Addendum #2

Re: **Addendum No. 2**
Richmond Community College
Hendrick Center for Automotive Training
1042 West Hamlet Avenue
Hamlet, NC 28345
ADW Project Number: #23014

These clarifications constitute Addendum No. 2 and considered part of the Bid Documents. General Contractor shall see that their sub-contractors are in full receipt of the information contained herein.

A600

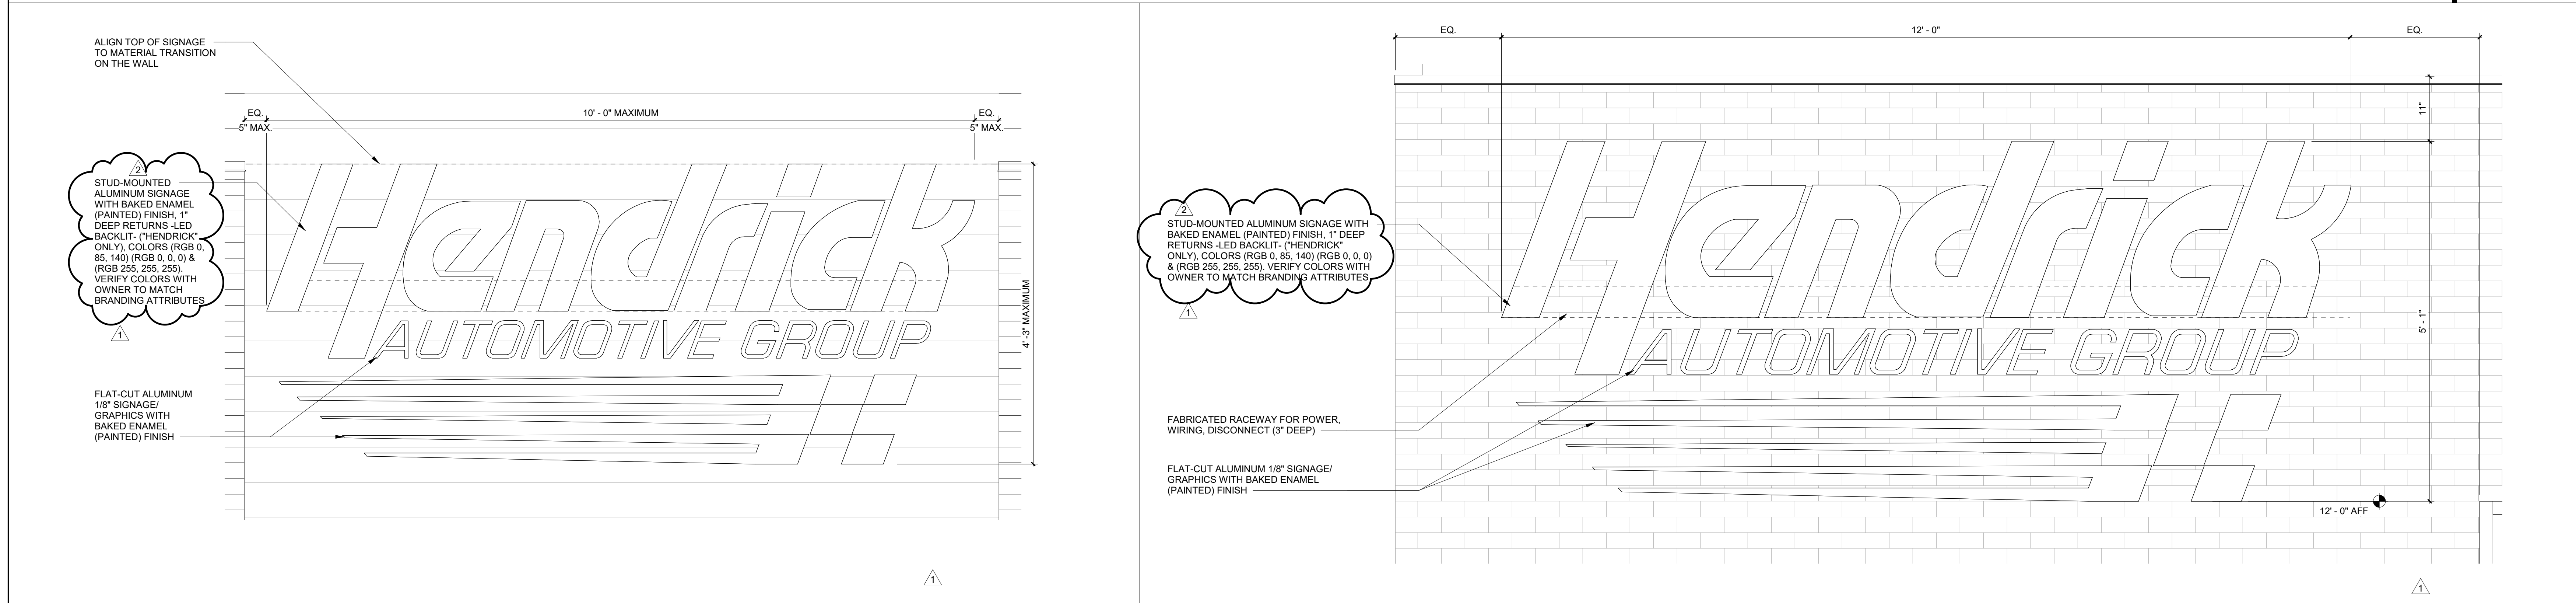
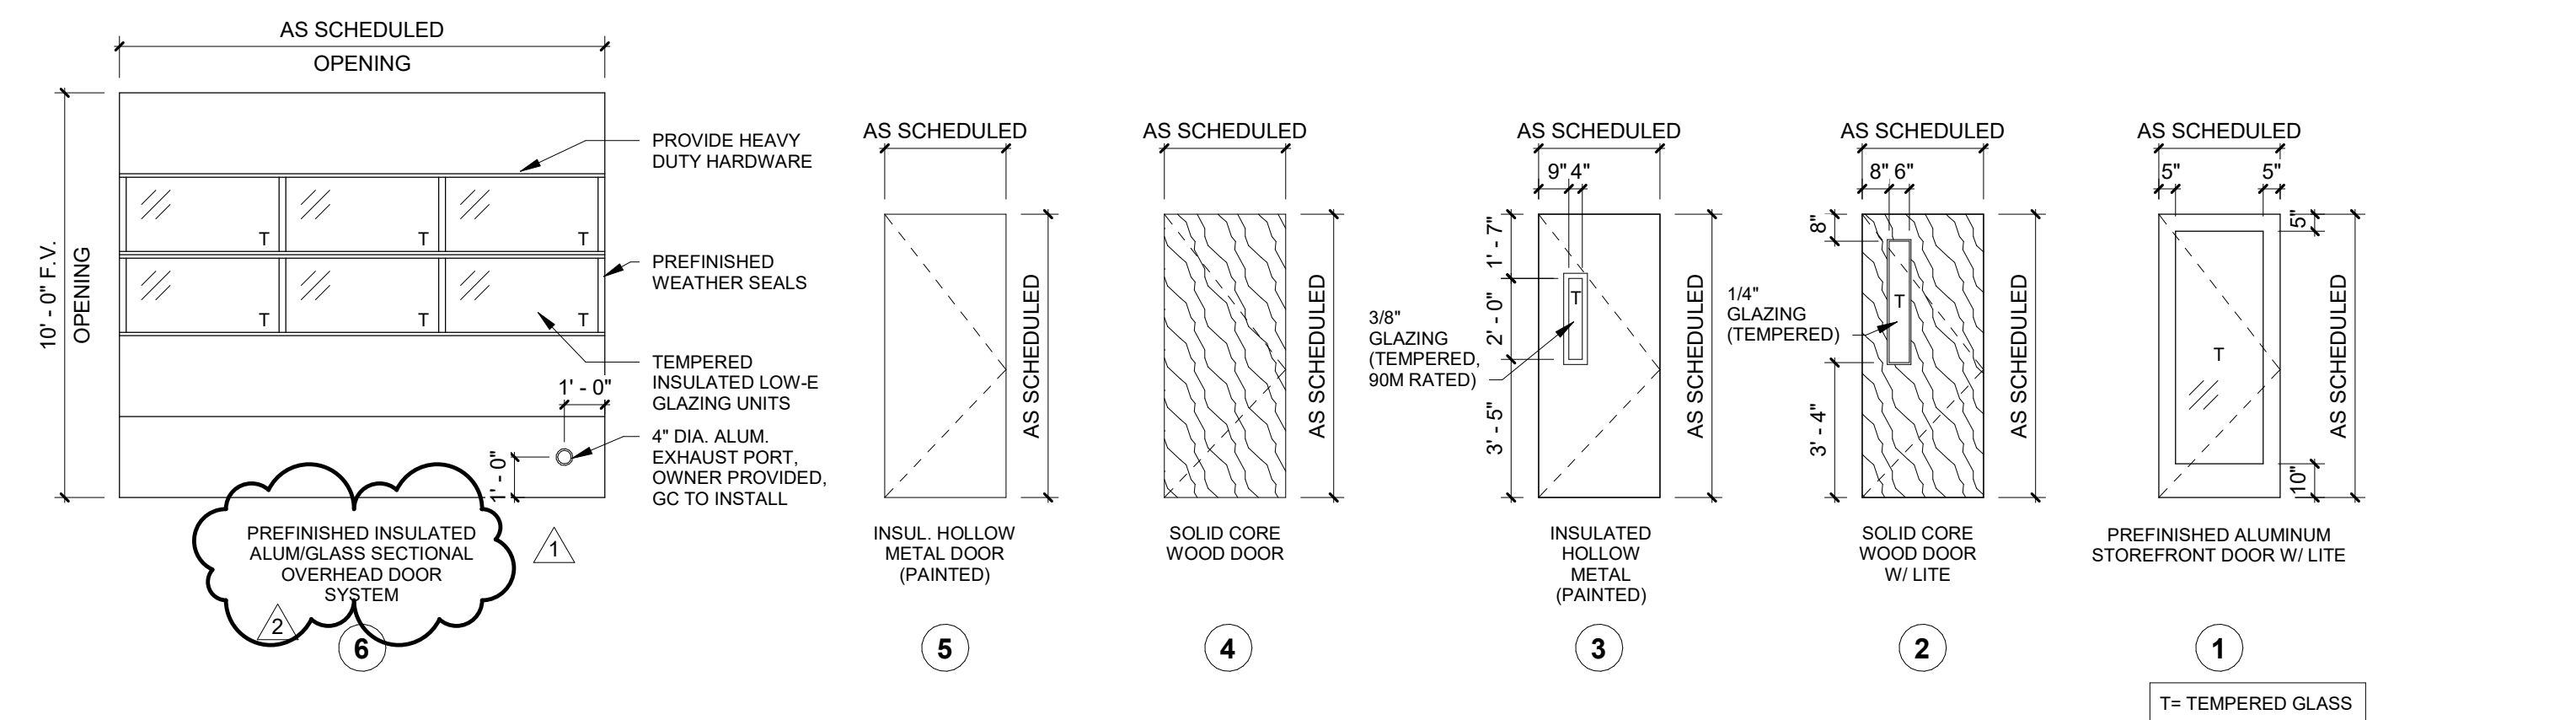
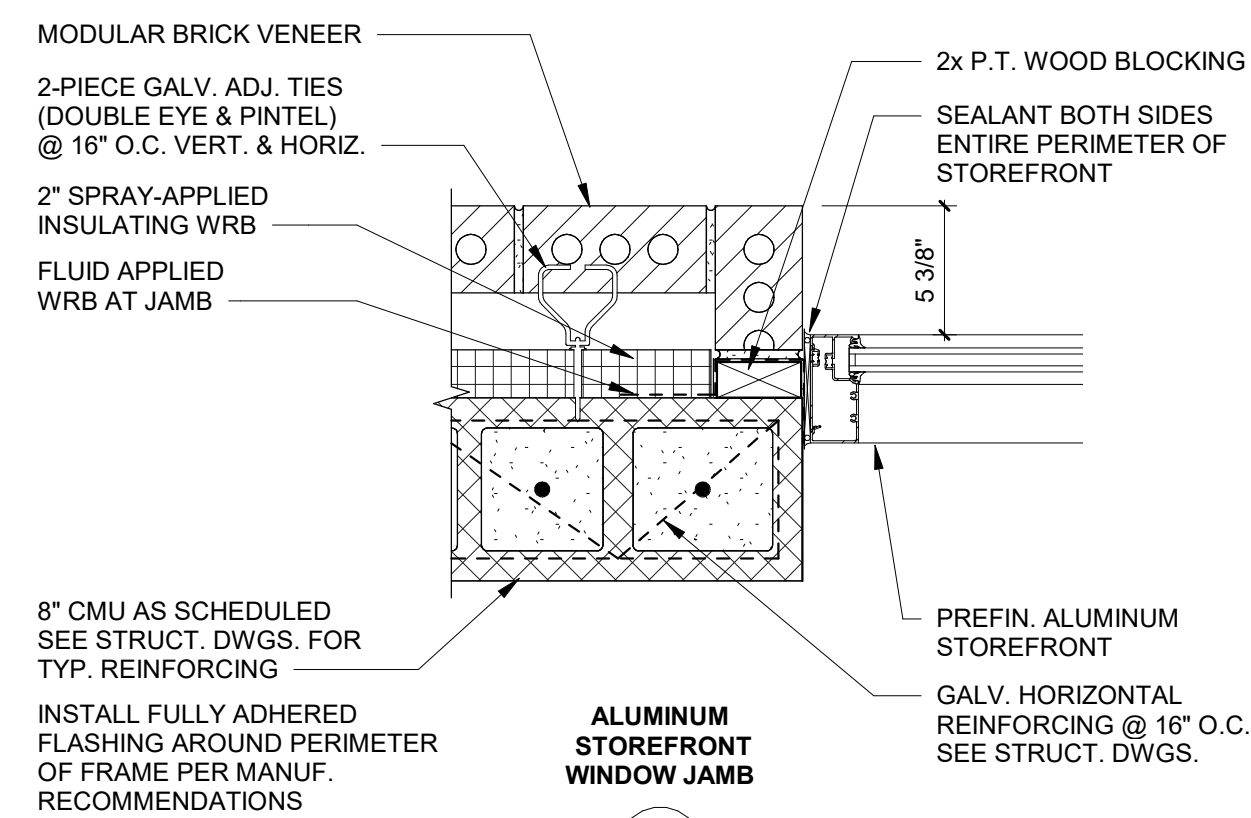
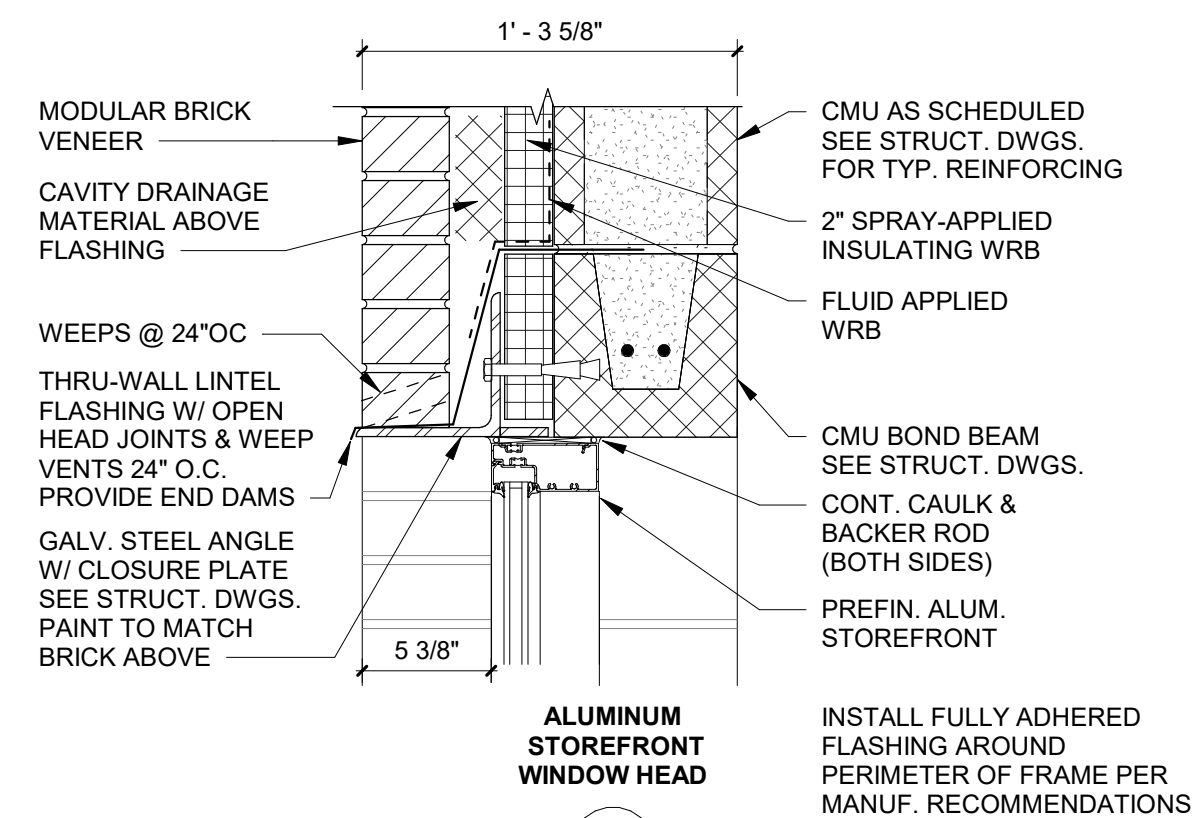
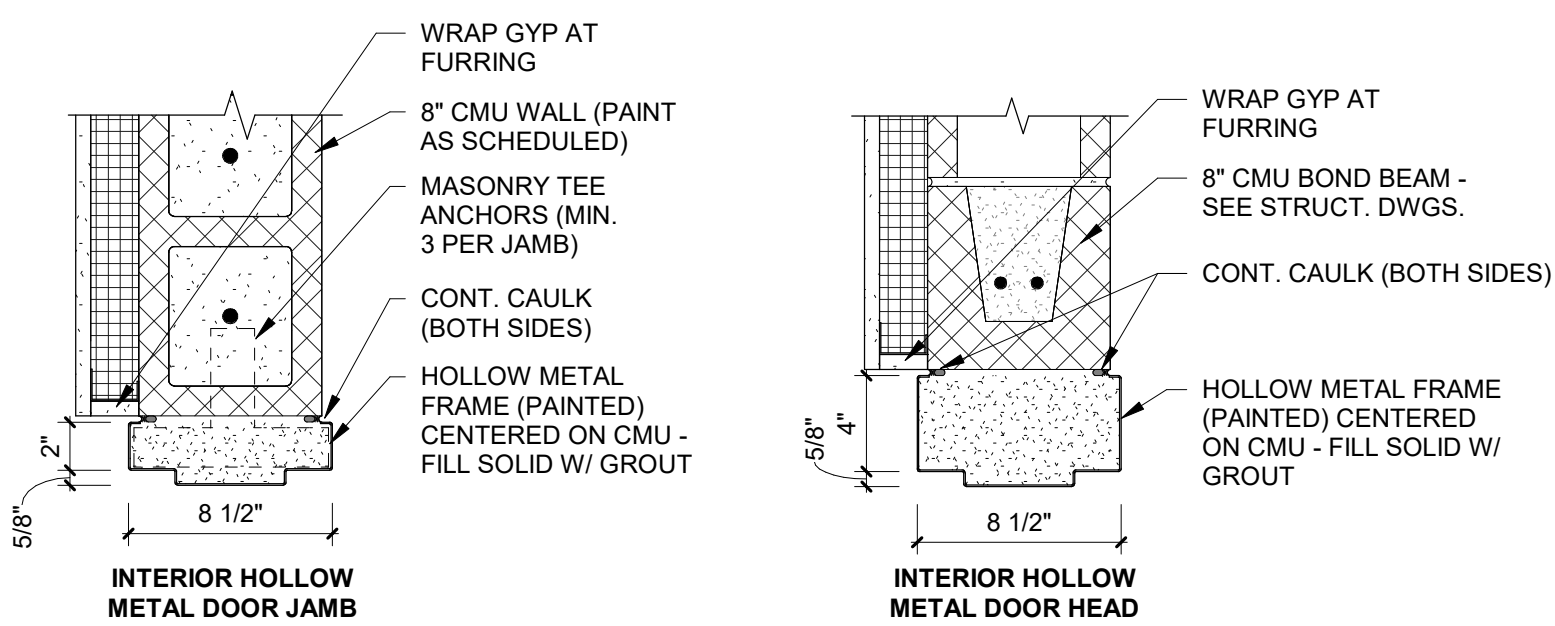
- 1.) A1200
 - a. Details 2 and 3: Delete “PREFINISHED STAINLESS STEEL SIGNAGE” from note.
- 2.) C200
 - a. Revised Sheet C200 to adjust the location of the sanitary sewer to avoid the trees.
- 3.) A600
 - a. Change door material in schedule and door types to Aluminum for overhead doors 114D, 114E and 114G.

- a. Delete “PREFINISHED STAINLESS STEEL SIGNAGE” from note.
- 4) RFI: The specifications call for a Full View Aluminum type Sectional Door, but the drawings indicate an Insulated Steel Door with (2) rows of Full View Sections. This causes a problem with the products specified with each manufacturer. Can it be clarified that the doors will be polyurethane insulated with (2) rows of Full View in each door?

- a. Overhead doors should be aluminum, insulated with two full view sections. See revised sheet A600.
- 5) RFI: The paint process with an insulated steel door panel would be a post paint in lieu of powder coat paint. Please clarify that if the polyurethane insulated panels/doors are what is intended that the paint specification be changed from powder coat paint to either baked enamel or a post paint process.

- a. Overhead doors should be aluminum with powder coat finish.
- 6) Per review of the civil plan sheet C200. The new sewer line location as shown on the noted above plan sheet will be cutting through the existing tree root ball/root lines for the two existing trees and this will kill these two existing trees. Please review the attached red line plan on this issue and confirm the new sanitary sewer line extension can be relocated to run along the edge of the existing sidewalk. Confirm the location of the existing water lines for the existing water utility locations as shown on this plan to coordinate the new installation of new sewer line.

NORTH ELEVATION LOGO SIGNAGE #6 1" = 1'-0" 3

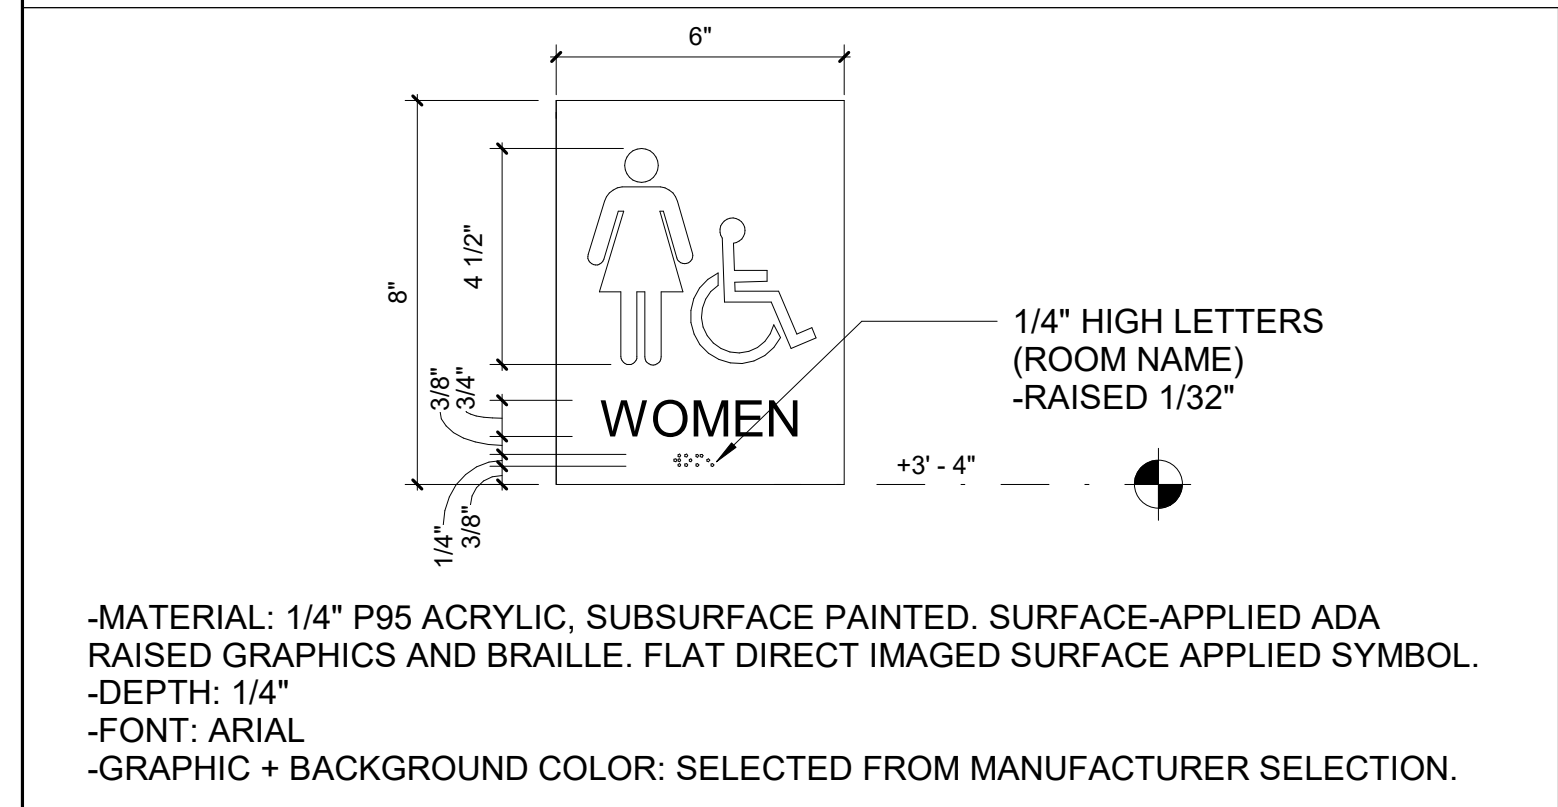
- 3) A1200 detail # 6. The Hendrick sign is stating “Stud-mounted aluminum signage with baked enamel painted finish, prefinished stainless-steel signage- 1” deep returns” This statement is calling for this sign to be made given two different directions. Please confirm if the channel letter housings for each letter are to be made out of aluminum and the faces for each of the letters are to be made out of stainless steel. The stainless steel will be more expensive and will drive the cost of these signs.
